PROJECT: Skye Canyon - Parcel 2.27 - Update

DRAINAGE PLAN REVISION LETTER

Skye Canyon Parcel 2.27
(Aka: Pinyon Chase)

Subject: Skye Canyon Parcel 2.27 (Aka: Pinyon Chase) – Drainage Plan Revision Letter (CLV DS4899 & Drawing No. 107Y5063-1)

SKYE CANYON PARCEL 2.27 ADDENDUM NO.1
BY OLYMPIA COMPANIES
EAGLE CANYON LATERAL P4-L1 THRU PARCEL 2.27

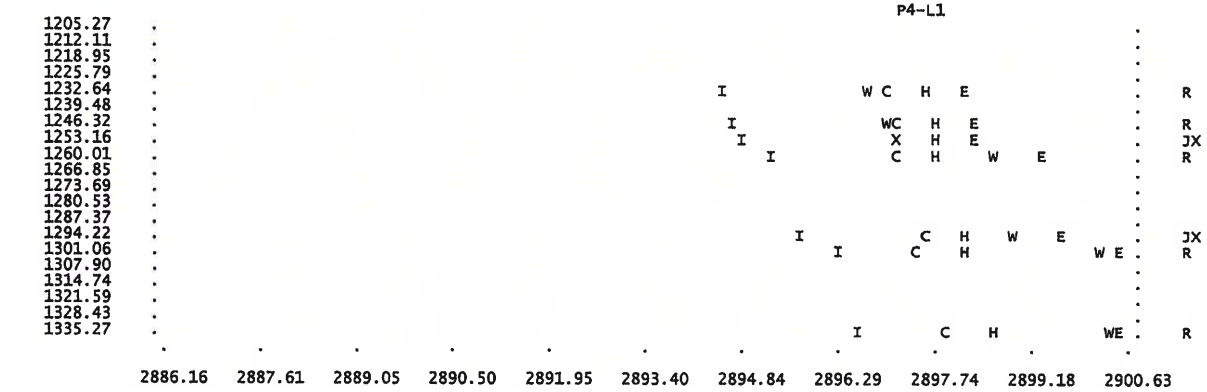
Hals still maintain more than 1.0-ft below the grate elevations at the low point of revised street profile

Prior Approved Drainage Exhibit

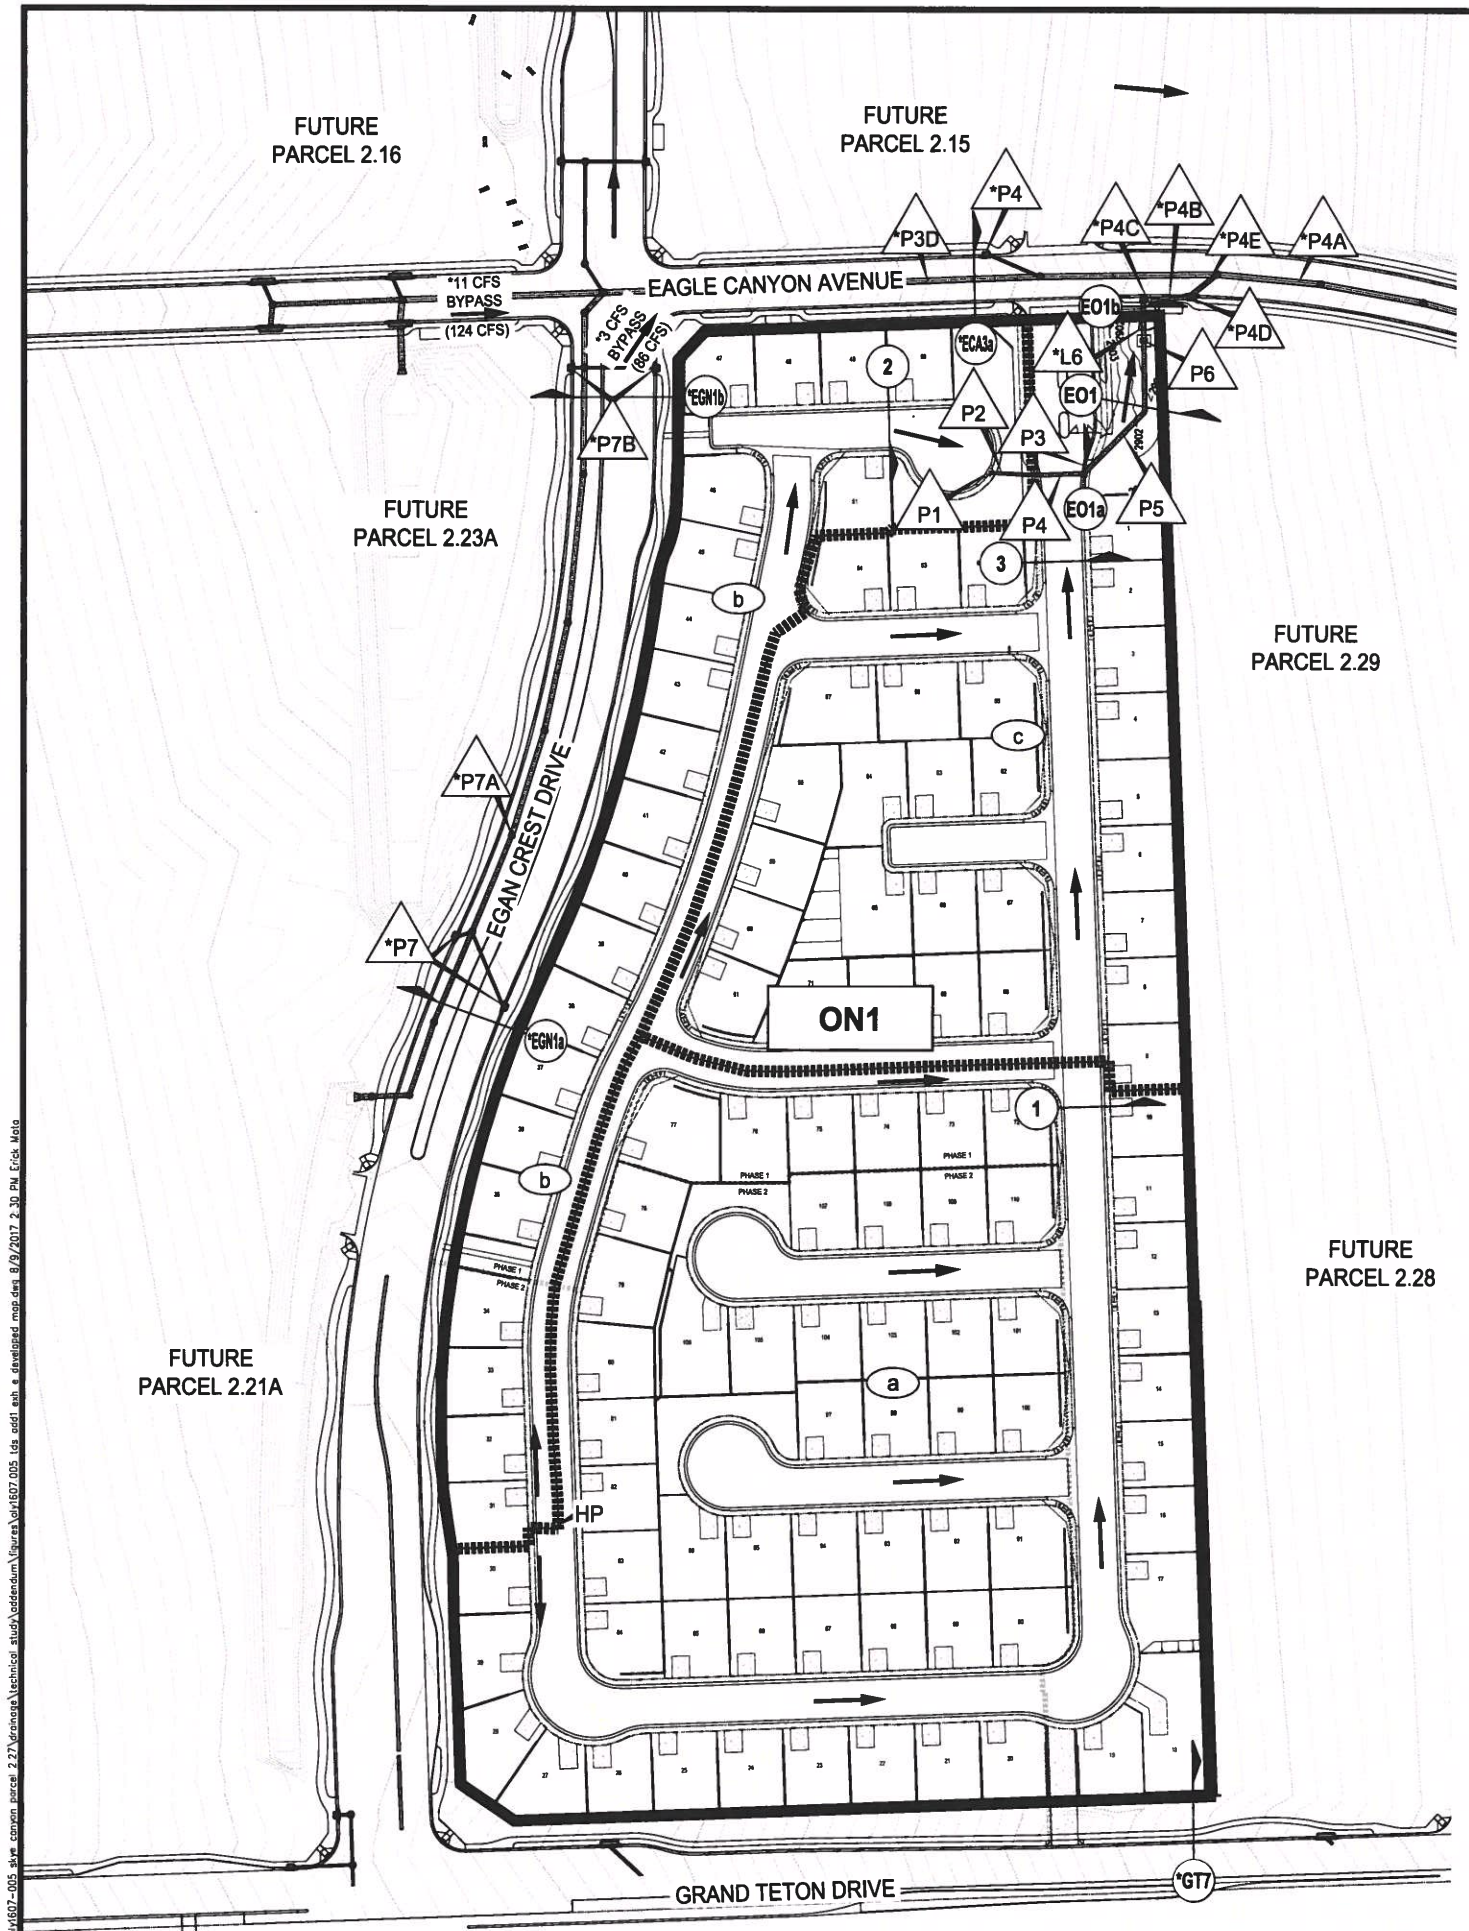
Revised hump of Street profile maintains 6" above flow depth

PLAN AND PROFILE - STORM DRAIN LATERAL

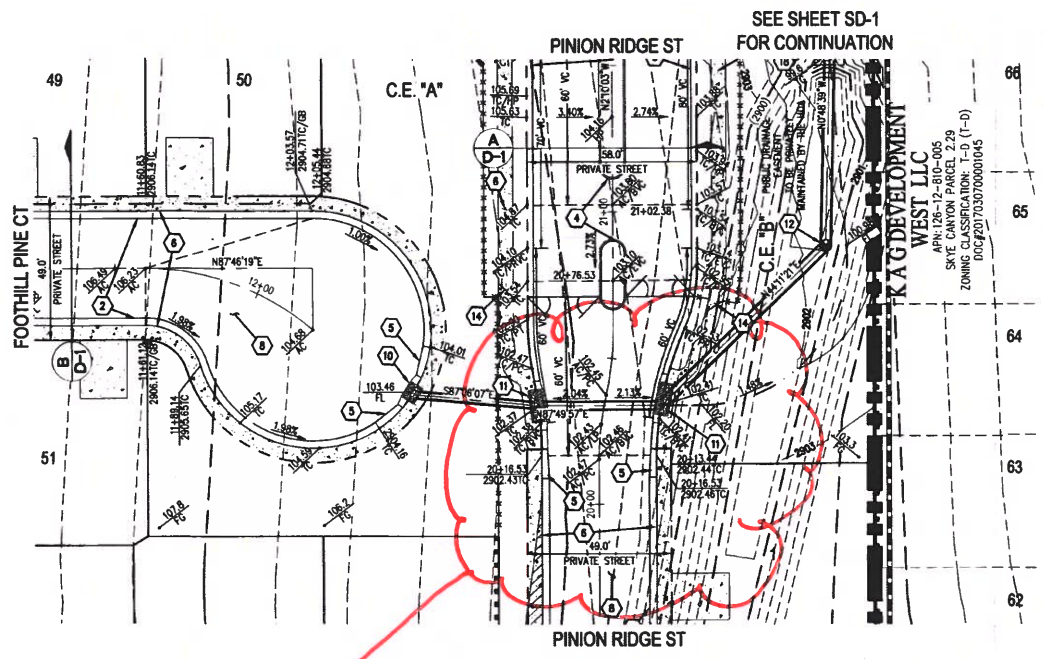
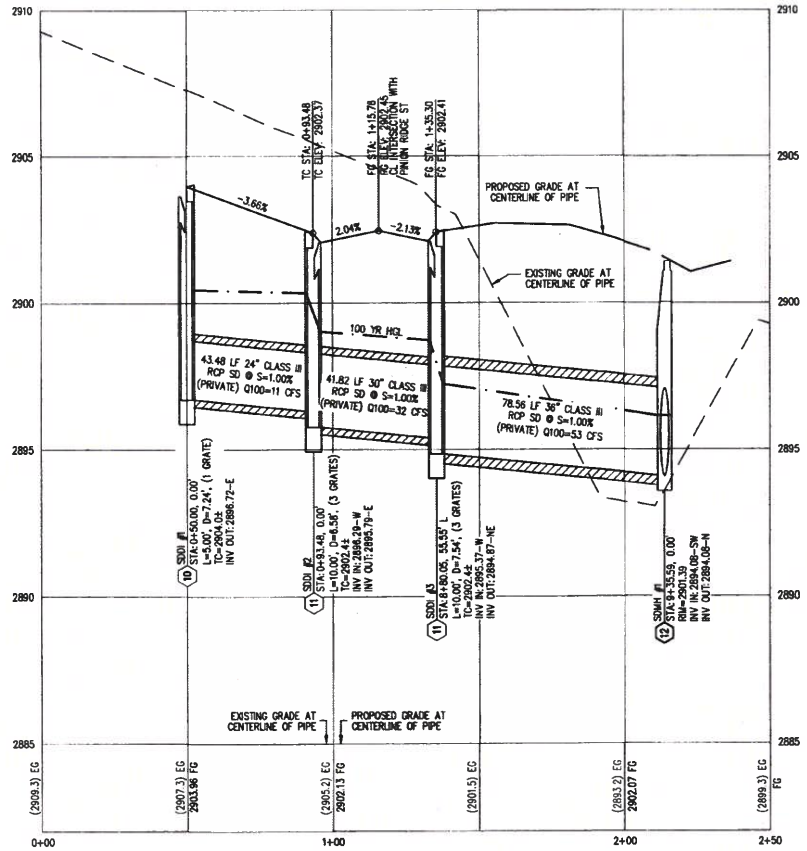
Low point has been lowered due to revised Street profile
